LONDON BIGGIN HILL AIRPORT RUNWAY 03 INSTRUMENT APPROACH PROCEDURE AIRSPACE CHANGE DECISION

CAP 2500

Figure 1 - Biggin Hill RNP IAP Runway 03 Chart V3.2

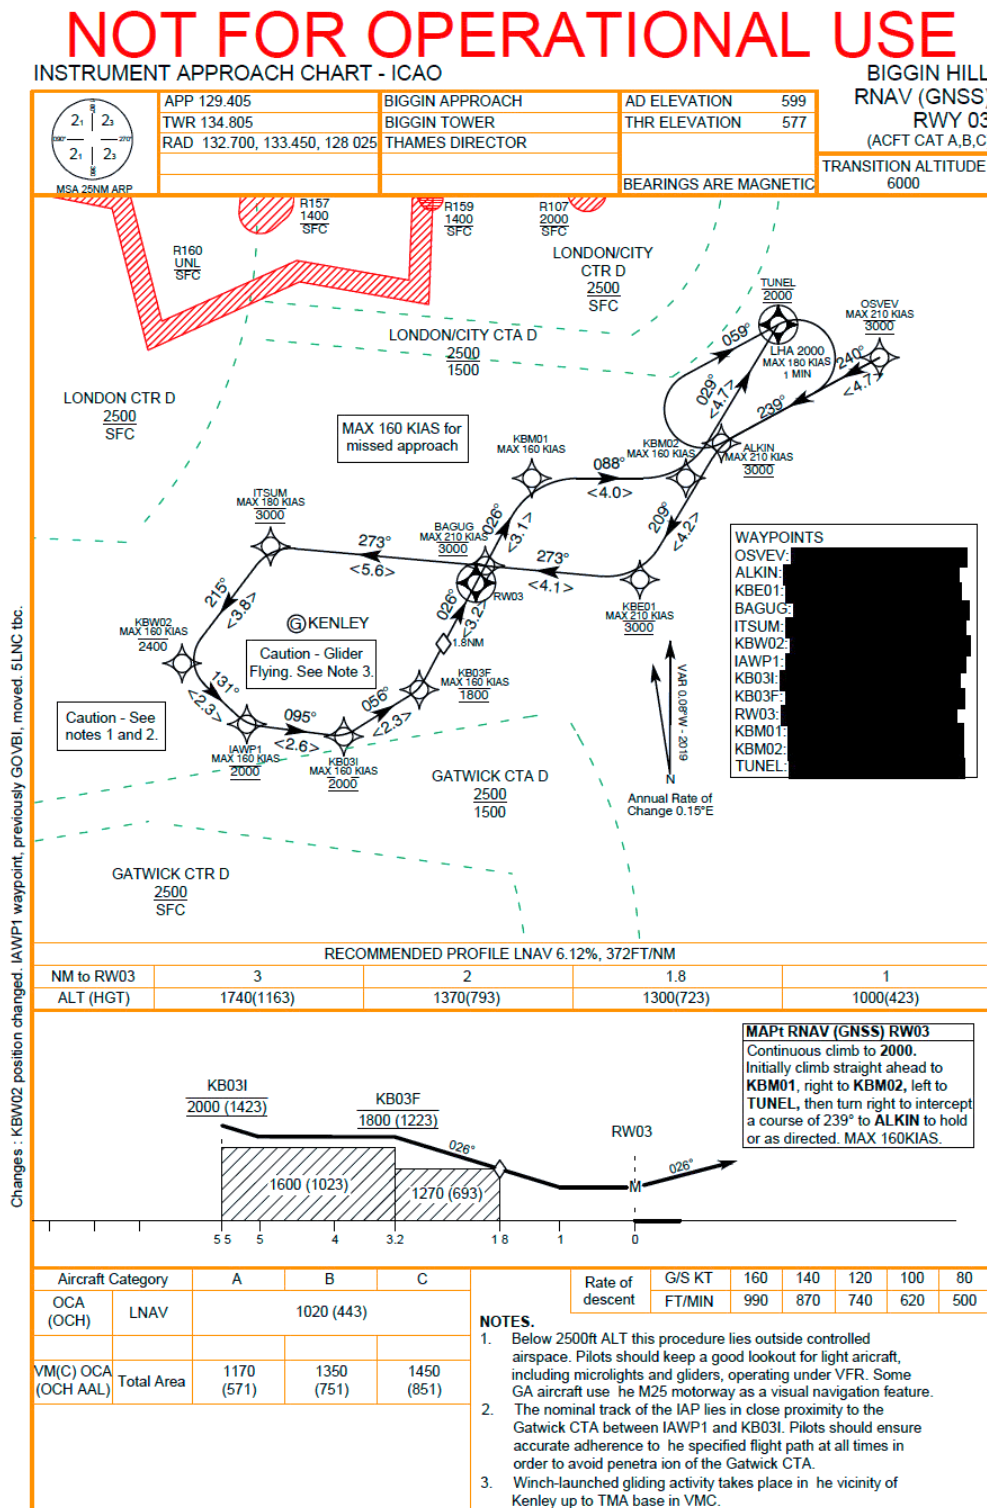
79. Following design changes leading up to the ACP Addendum submission, the CAA received Addendum IFP Assessment package V3.2 on 09 Sep 2020. Annex A Figure 1 shows Biggin Hill RNP IAP Runway 03 Chart V3.2.

80. CAA IFP Regulation assessed V3.2 providing a technical report, coding table, and feedback form to the sponsor's APDO on 09 Mar 2021. This provided considerations on the way ahead and clarification on how design criteria should be implemented, in particular to the intermediate segment. Several concerns were highlighted including a request for the non-compliant segment to be redesigned.

Figure 2 - Biggin Hill RNP IAP Runway 03 Chart V3.3

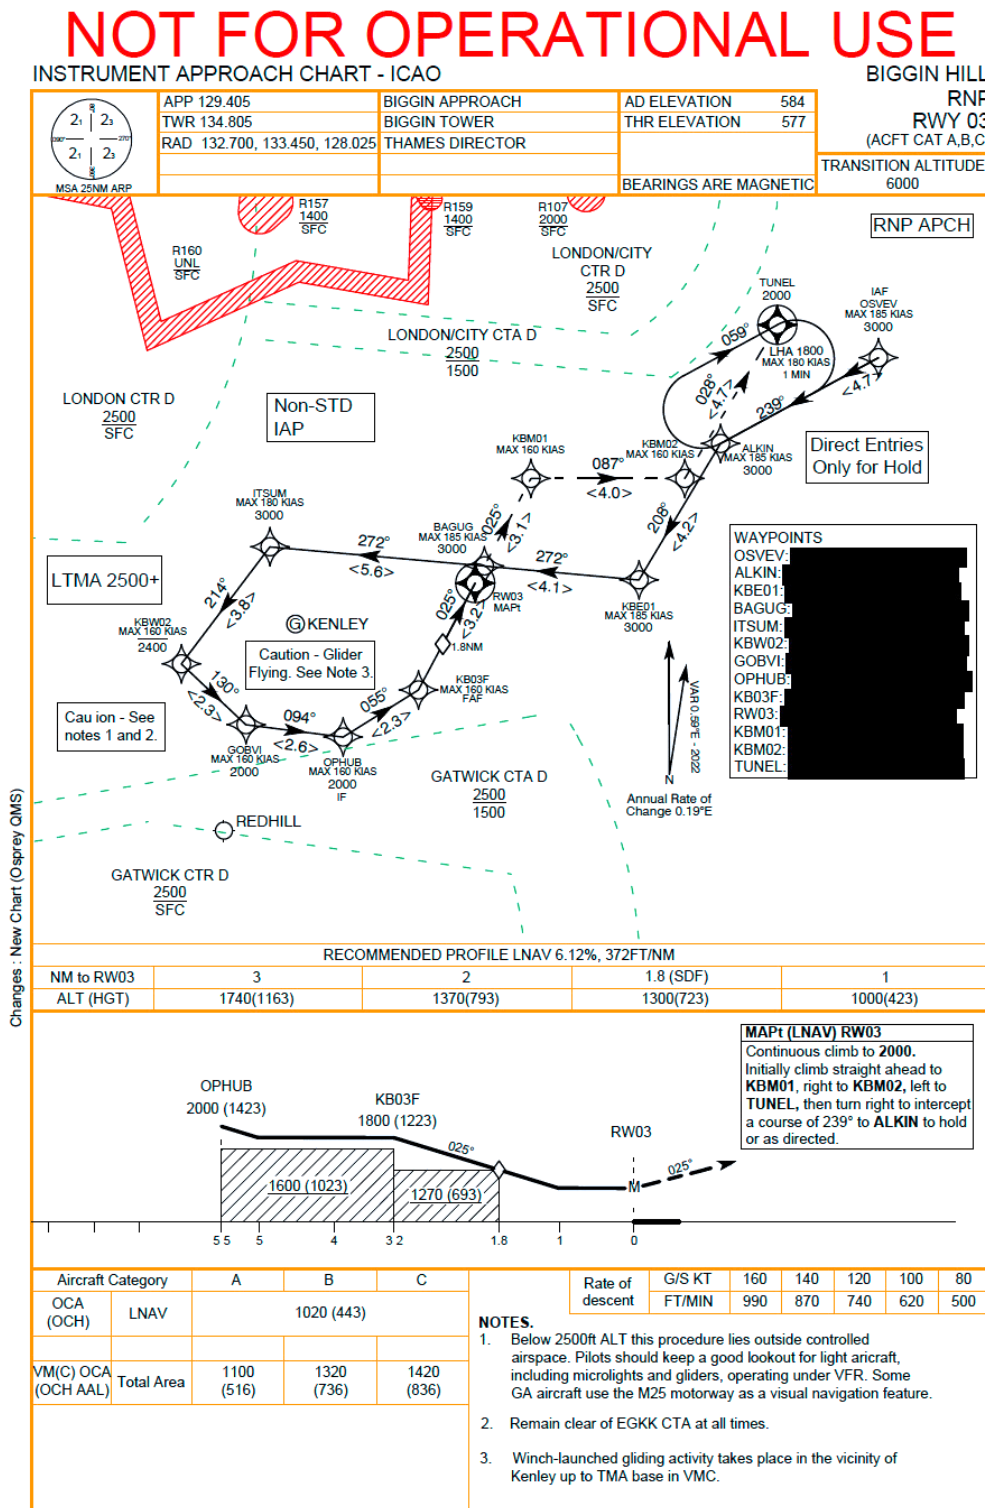
81. The sponsors APDO responded to the CAA technical report on 24 Sep 2021, submitting V3.3 (Annex A Figure 2). In this the CAA concerns over the complexity and non-standard nature of the proposal, including the request for the non-compliant segment to be redesigned, have not been addressed. The following list summarises the outstanding issues:

- a) The IAP as proposed is non-standard in content. The norm in the UK for an RNP (Required Navigational Performance) IAP is a T-Bar, Y-BAR or straight-in runway aligned IAP, whereas this IAP is presented as a figure of eight (8). This design and its presentation will increase the workload for pilots in ensuring the IAP is understood and flown correctly.

- b) The segments lengths from ITSUM are all of a minimum length which means there is no flexibility available should the many variables which can cause a procedure to breakdown occur, e.g., weather conditions, aircraft/flight management system (FMS) issues, pilot actions when correcting FMS discontinuities, waypoint (WP) bypass etc.

- c) With descent mandated after ITSUM into an area of busy GA traffic the extensive track miles of the procedure, west of Kenley down to and along the M25 while routing east to Biggin Hill, will exacerbate the issues of pilot workload, interactions with other airspace users, and create possible conflicts in Class G.

- d) The segment length between KEW02 and GOBVI does not support stabilised flight in all circumstances e.g. a strong tailwind on the downwind section.

- e) The intermediate segment (IF) is non-compliant as the length is less than that required to support a stabilised approach by all aircraft.
 - f) The use of a step-down fix (SDF) to achieve a lower procedure minimum adds further complexity to an already complex non-standard IAP.

- g) The visual segment surface (VSS) penetrations have not been removed. The assessment of an OCS (obstacle clearance surface) does not remove the requirement of the sponsor to remove the VSS penetrations. VSS penetrations would need to be removed to ensure any IAP to runway 03 can be viable in the future.

- h) Chart clutter is caused by the complex and non-standard nature of the IAP.
 - i) Due to the number of issues raised above, the CAA does not accept that the impacts on human factors and pilot workload have been suitability mitigated within this proposal. Additionally, the workload will be increased for pilots arriving from outside of the UK, who are used to flying IAPs which are wholly contained within controlled airspace.
